**MULTISITE ROOFING 2019 – RE-BID**  
South Eugene High School  
Kennedy Middle School  
C.I.P. No. 420.780.209

**ROBERTSON/SHERWOOD/ARCHITECTS pc**  
132 E. Broadway - Suite 540  
Eugene, Oregon  
Project No. 1901

Drawn By BDH	ADDENDUM NO. 1	Robertson   Sherwood   Architects pc				AD1 1
Checked		132 East Broadway, Suite 540 Eugene, Oregon 97401	P 541   342.8077 F 541   345.4302	www.robertsonsherwood.com		
Date 5/13/19	RE-BID	MULTISITE ROOFING 2019 - C.I.P. #420.780.209				
Project 1901		South Eugene High School & Kennedy Middle School

DETAIL A6/211 REVISED

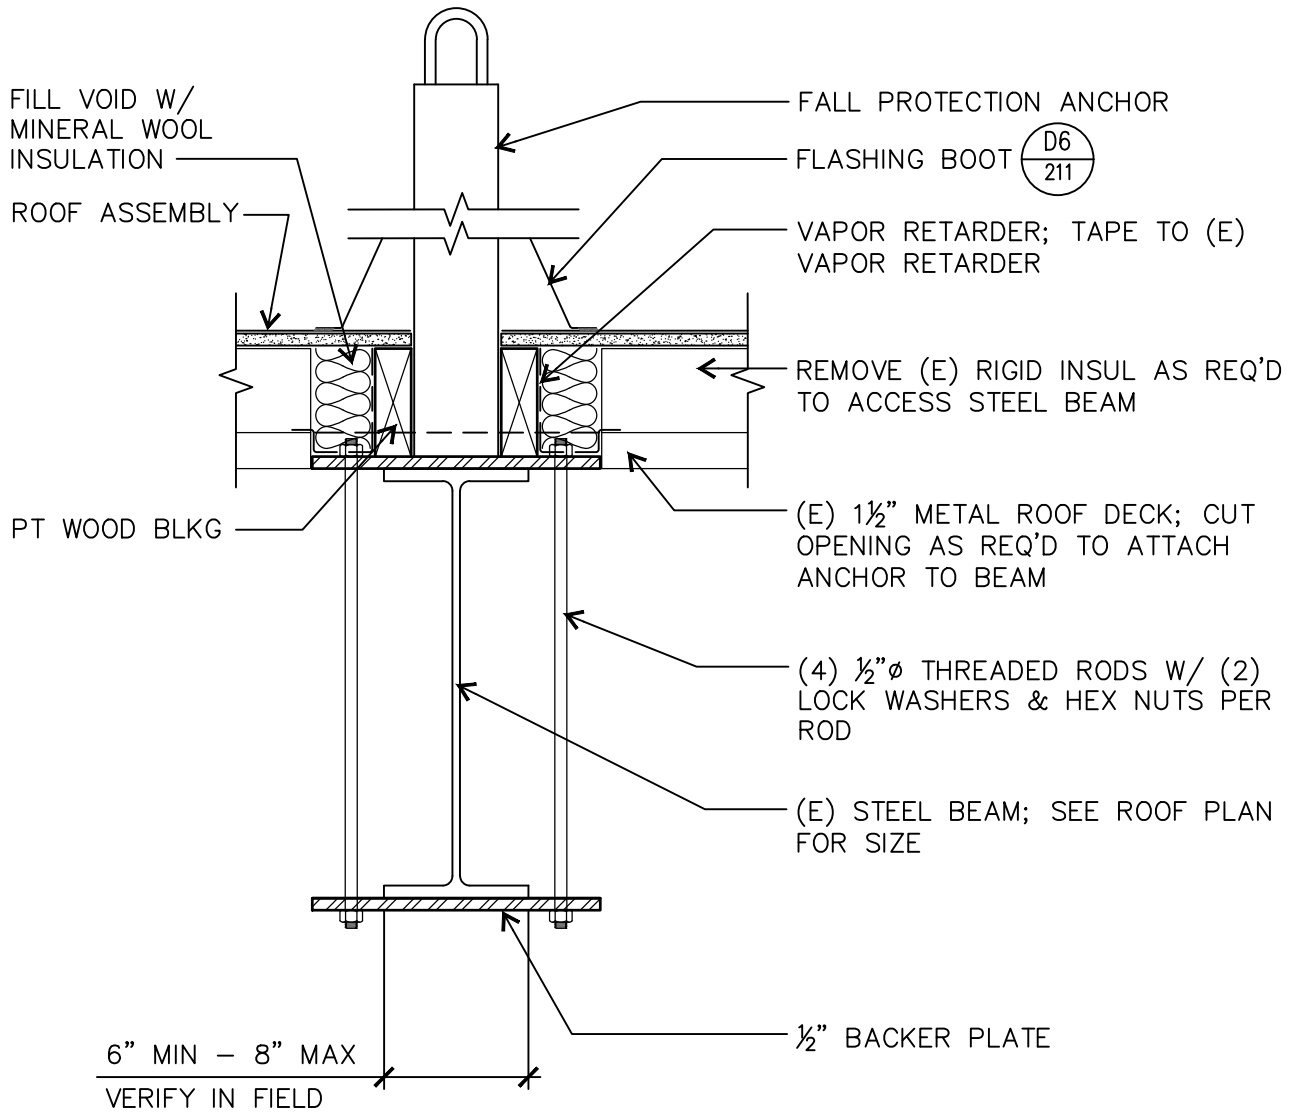
- A. Replace Detail A6/211 with new Detail A6 attached to this addendum. Clarification: Revised detail eliminates welding anchors to existing steel beams.
